SUBJECT: Forwards responses to 800307 hydrologic engineering questions re waste treatment sys, to assist NRC environ review of Unit 2. Affidavit encl.

Subject: WPPSS NUCLEAR PROJECTS NOS. 1, 2 AND 4
HYDROLOGIC ENGINEERING QUESTIONS

HYDROLOGIC ENGINEERING QUESTIONS

WPPSS-2 AND 1/4 SEWAGE TREATMENT FACILITY

FIGURE 6.4
WPPSS LAGOON TREATMENT
FACILITIES
RICHLAND WASHINGTON
**TYPICAL EMBANKMENT
SECTION**

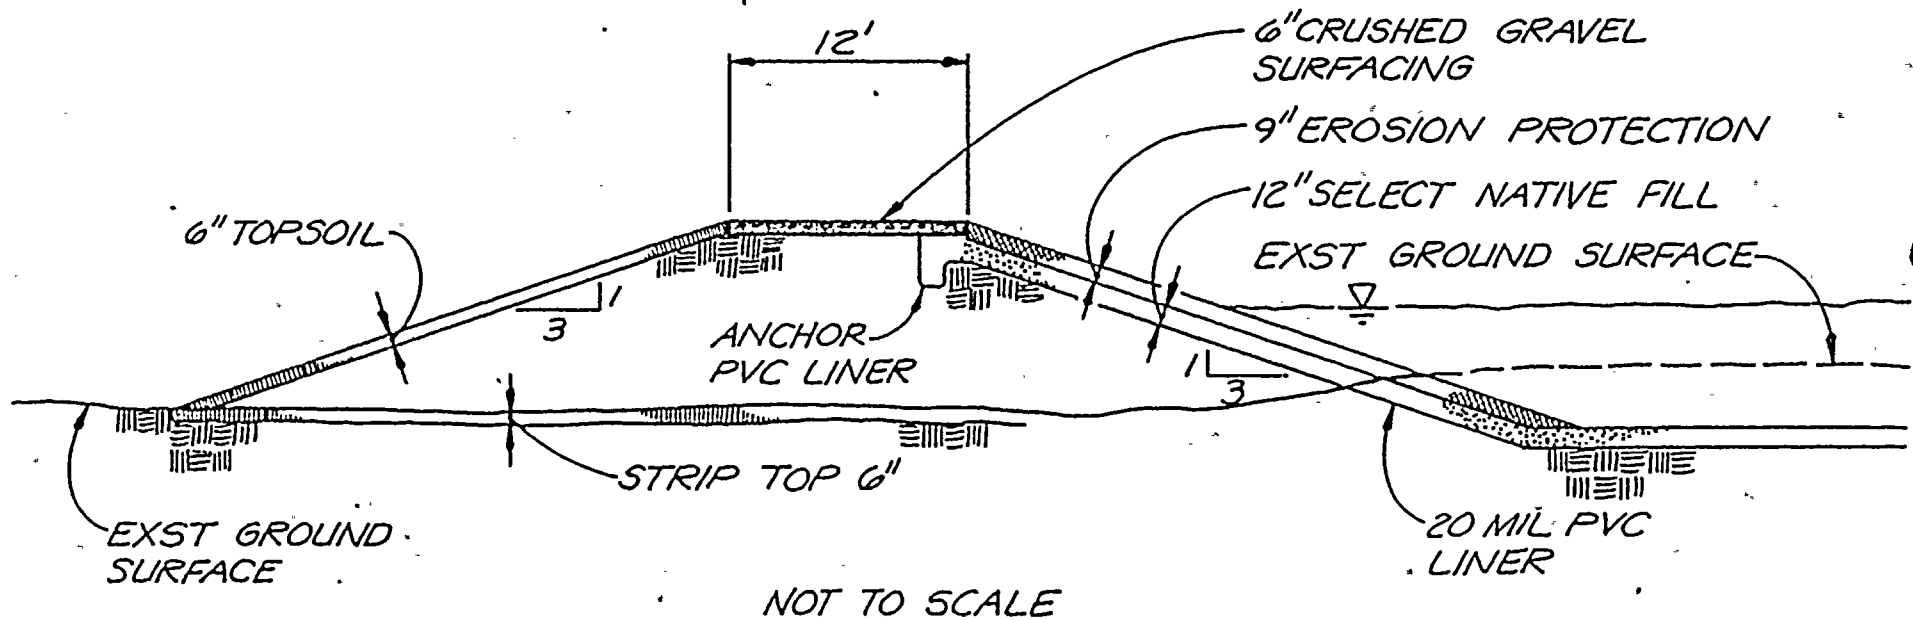
Provide additional information regarding the liner that will be used to prevent seepage from the primary lagoon. This information should include liner permeability, liner strength, and durability construction techniques, and bases for the values reported.

The liner which will be used to prevent seepage in both the primary (aerated) ponds and the secondary (stabilization) ponds will be a 20-mil polyvinyl chloride (PVC) membrane. It will be installed over a prepared subgrade, then covered with 12 inches of native material for sunlight and tear protection.

The strength and durability characteristics of the liner are listed on attachment B. Construction techniques are shown on attachment C.

FREQUENCY CURVE OF ANNUAL MOMENTARY
PEAK FLOWS FOR THE COLUMBIA RIVER
BELOW PRIEST RAPIDS DAM, WA

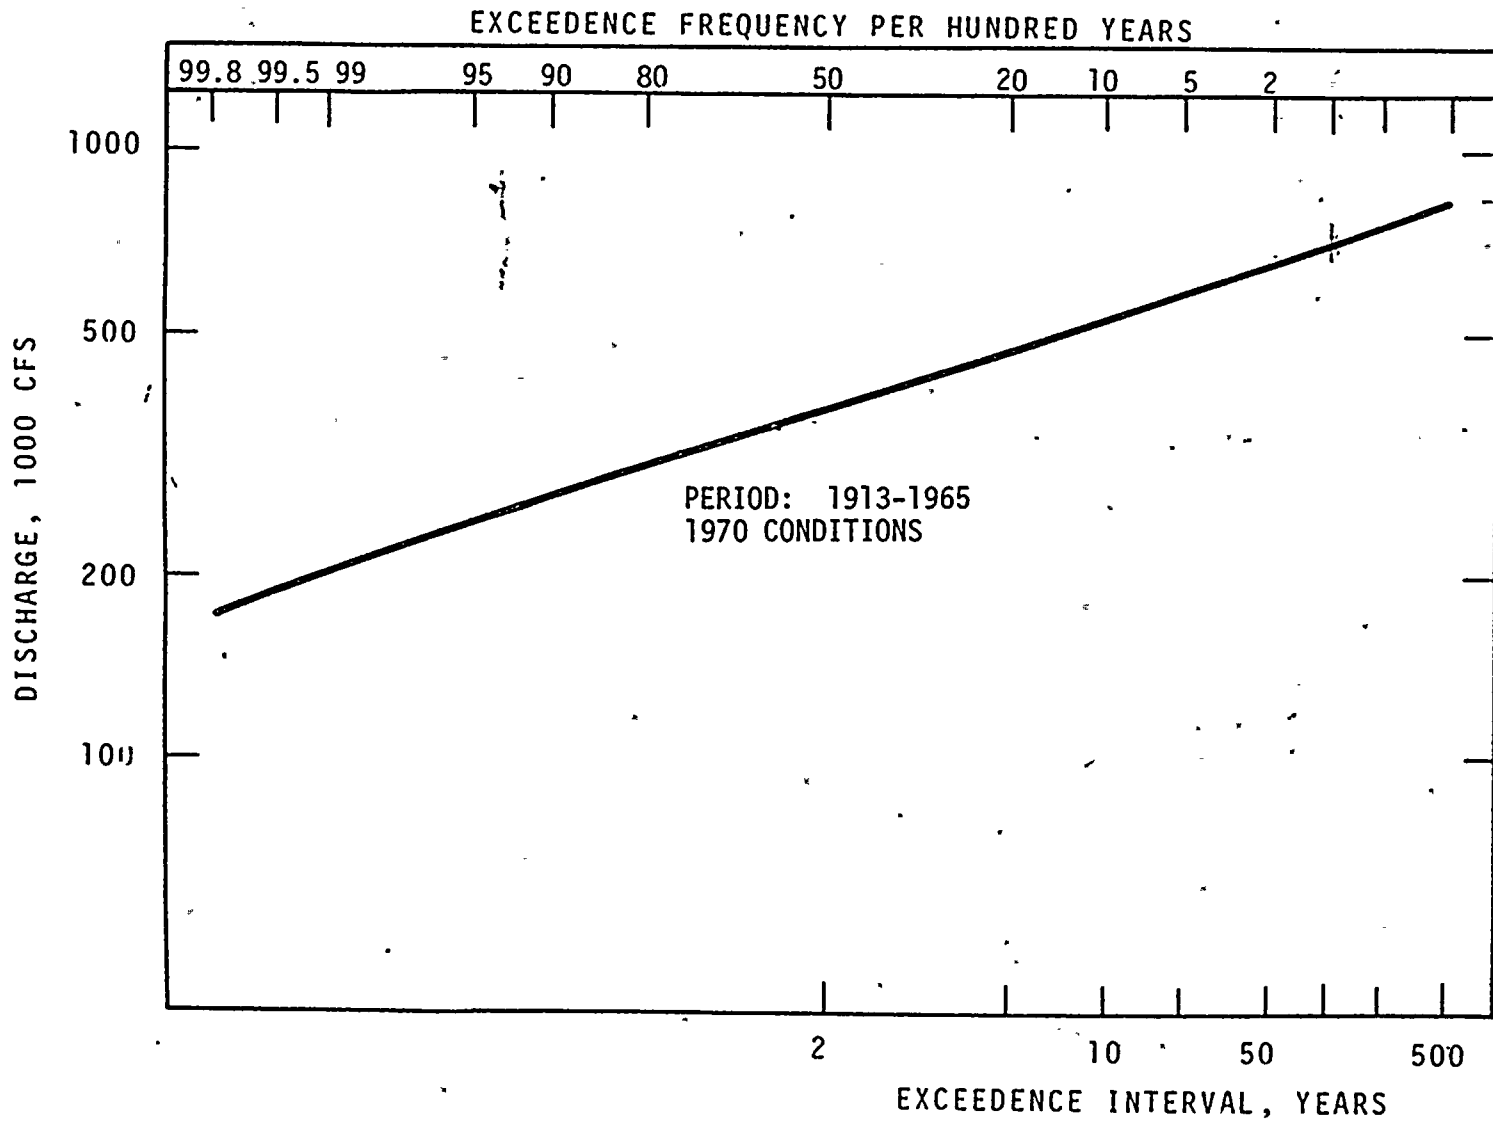
- a) Provide descriptions of the floodplains of all water bodies, including intermittent water courses within or adjacent to the site. On a suitable scale map provide delineations of those areas that will be flooded during the one-percent chance flood in the absence of plant effects (i.e., pre-construction floodplain).

The flood history of the Hanford Reach of the Columbia River is discussed in Section 2.4 of the WNP-2 FSAR. The derivation of critical flood elevation and the references utilized are reported therein. The Standard Project Flood (SPF) has been defined by the Army Corps of Engineers as 570,000 cfs, which represents a 367 ft. MSL elevation at the WNP-2 intake. The makeup water pumphouse operating floor elevation is 375 ft. MSL. The lowest elevation of the Sanitary Waste Disposal System is 414 ft. MSL at the percolation beds. The one-percent flood represents 650,000 cfs and 370 ft. MSL elevation at the WNP-2 intake (please see Attachments D and E, which are respectively, Figure 2.4-3 of the WNP-2 ER-OL and Figure 2.4-14 of the WNP-2 FSAR). Attachment F shows the topographic detail of the site vicinity.
